Concerned Products:	Customer Notification	Date: 16 March 2000
<p><i>μPD784224</i> <i>μPD784224Y</i> <i>μPD784225</i> <i>μPD784225Y</i></p> <p><i>μPD78F4225</i> <i>μPD78F4225Y</i></p>		NEC-Electronics (Europe) GmbH EAD -Technical Product Support
Bug Report		Source Doc: SBG-T-0483 SBG-T-0504 SIF-T-?? (TQ-TH970820/1) SIF-T-10395 (TQ-TH971215/2) SBG-T-0619 NN
		Author: A. Twardy
Date of initial issue: 07 August 1998		Doc. No.: TPS-LE-B-4223

(A) BUG LIST

(B) BUG DESCRIPTION

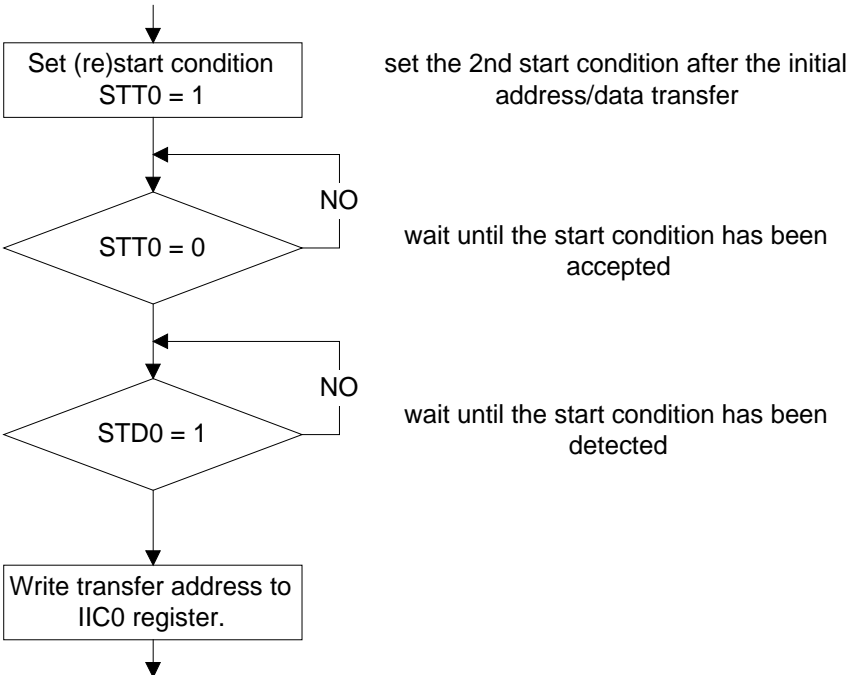
Bug No.	Outline	Description
1	<p>Cancelling the IDLE mode may cause a wait during the oscillation stabilization time that has been set by oscillation stabilization time specification register (OSTS).</p>	<p><u>Details</u></p> <p>When a contention occurs between the execution of an IDLE mode instruction and an interrupt to release the IDLE mode, STOP mode is released after executing STOP mode, rather than IDLE mode being released after executing IDLE mode as it should.</p> <p>Therefore, despite the fact that the program has set the IDLE mode, this bug results in a wait for the length of oscillation stabilization time that is set by the oscillation stabilization time register (OSTS), when cancelling this mode. Normally, when cancelling the IDLE mode, there is no need to wait for the duration of the oscillation stabilization time.</p> <p>Specifically, when the bug occurs, an operation as shown in the following timing chart is performed.</p> <p style="text-align: center;">Input of a standby release signal during this period (about 0.1 ns) will cause the bug</p> <p>System clock *1</p> <p>Standby mode signal *2</p> <p>Standby release signal *3</p> <p>Standby signal ① *4</p> <p>Standby signal ② *4</p> <p>System clock trailing edge: Determined to be STOP mode at this time.</p> <p>Normal operation</p> <p>Standby mode signal *2</p> <p>Standby release signal *3</p> <p>Standby signal ① *4</p> <p>Standby signal ② *4</p> <p>Because of the high level of both standby signals during the high period of the system clock, this becomes IDLE mode.</p> <p>*1: Internal system clock *2: The signal notifying entry to entering each standby mode, While the system clock is high, the values of standby signals ① and ② are latched, and signals to select which standby mode to enter are created. *3: The standby mode release signal created by the microprocessor by inputting the standby mode release factor. *4: STOP mode: Signal ① = 1, Signal ② = 0 HALT mode: Signal ① = 0, Signal ② = 1 IDLE mode: Signal ① = 1, Signal ② = 1</p>

Bug No.	Outline	Description
1	(continuation)	<p><u>Description of timing chart</u></p> <p>First, standby signal ① and ② is changed by executing the IDLE instruction. Then, while the system clock has high level, the values of standby signals are latched. Selection of the standby mode to enter is set by falling edge of the system clock.</p> <p>The standby mode signal is placed in IDLE mode if the standby signals ① and ② are high level respectively while the system clock is high.</p> <p>The bug is generated when the standby mode release interrupt occurs after the standby mode instructions (MOV STBC, #byte) and immediately before the falling edge of the initial system clock.</p> <p>Because of the time difference generated after the standby release interrupt until the signals ① and ② are cleared, the system is placed in the STOP mode signal status when the system clock falls, which is neither IDLE mode nor normal mode. Consequently, the system is determined to be in the STOP mode, thus resulting in the wait for the duration of oscillation stabilization time upon cancellation of the standby.</p> <p><u>Workaround</u></p> <p>Unfortunately, it is impossible to take perfect countermeasures in software.</p> <p>As it was explained above, in order to stop this bug from occurring, it is necessary to make sure that the external interrupts and input to the IDLE instruction do not conflict with each other.</p> <p>So it is recommended, when using the IDLE mode, to shorten the value of the oscillation stabilization time, which is set by the OSTS register. This bug doesn't occur unless an external interrupt is generated during the short time of about 0.1 ns when executing the IDLE instruction. Therefore, the rate of occurrence is considered extremely low.</p>

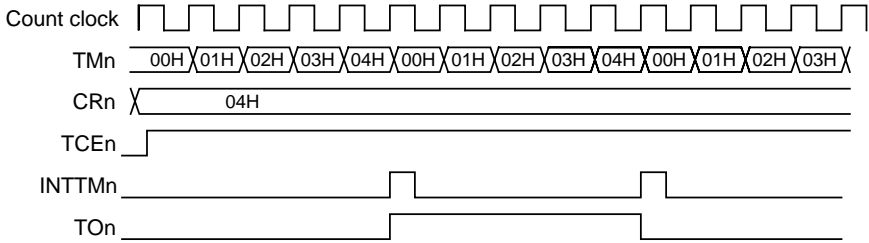
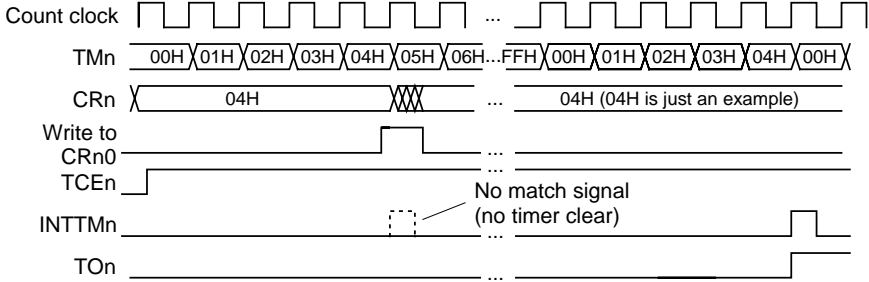
3	If the conversion result is read after halting the A/D conversion operation, the value may be undefined.	<p><u>Details</u></p> <p>If the timing for the A/D conversion end conflicts with that for halting the A/D conversion operation, an undefined value is stored into the ADCR. Reading the conversion result afterwards will result in reading an undefined value.</p> <p><u>Workaround</u></p> <p>Read the A/D conversion result register ADCR while the A/D converter is operating. When reading the conversion result after halting the A/D conversion, make sure that timing for halting A/D conversion does not conflict with that for the end of the A/D conversion.</p>

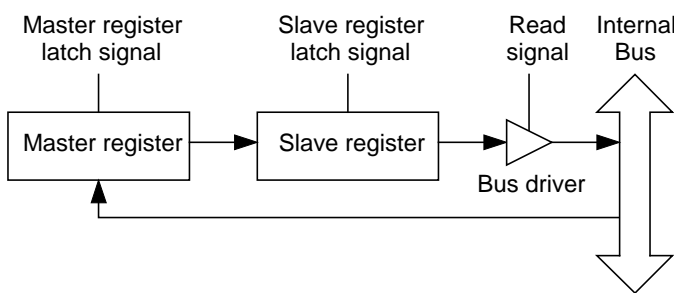
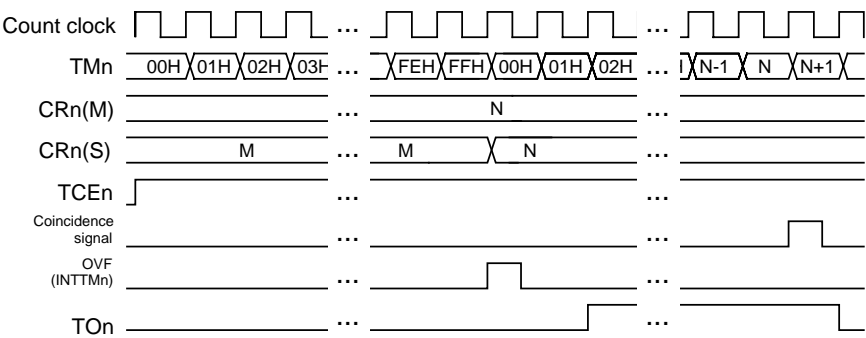
Bug No.	Outline	Description
4	Using the I ² C restart condition causes a faulty address transfer.	<p><u>Details</u></p> <p>If the transfer address is set to the shift register (IIC0) immediately after the (re)start is set (STT = 1), the transfer address will be sent simultaneously by rising edge of the serial clock (SCL).</p> <p>The serial clock is at low level normally before a restart condition will be set, due to the preceded address/data transfer. To generate a (re)start condition the serial clock (SCL) has to be first on high level (recessive state). By falling edge of the SDA line, when SCL has high level, the (re)start condition can be detected. Afterwards the SCL line will fall to low level and the slave address can be transferred by normal operation. Now, if the slave address is written into the shift register (IIC0) immediately after the start condition trigger (STT0) is set, the rising edge on the SCL line resulting in data output before the start condition is set. This causes the bug.</p> <p><u>Workaround</u></p> <p>The transfer address must be set after the confirmation of start condition detection (STT=0, STD = 1).</p>  <pre> graph TD Start(()) --> Set[Set (re)start condition STT0 = 1] Set --> STT0{STT0 = 0} STT0 -- NO --> STT0 STT0 -- YES --> STD0{STD0 = 1} STD0 -- NO --> STD0 STD0 -- YES --> Write[Write transfer address to IIC0 register.] Write --> End(()) </pre> <p>set the 2nd start condition after the initial address/data transfer</p> <p>wait until the start condition has been accepted</p> <p>wait until the start condition has been detected</p>
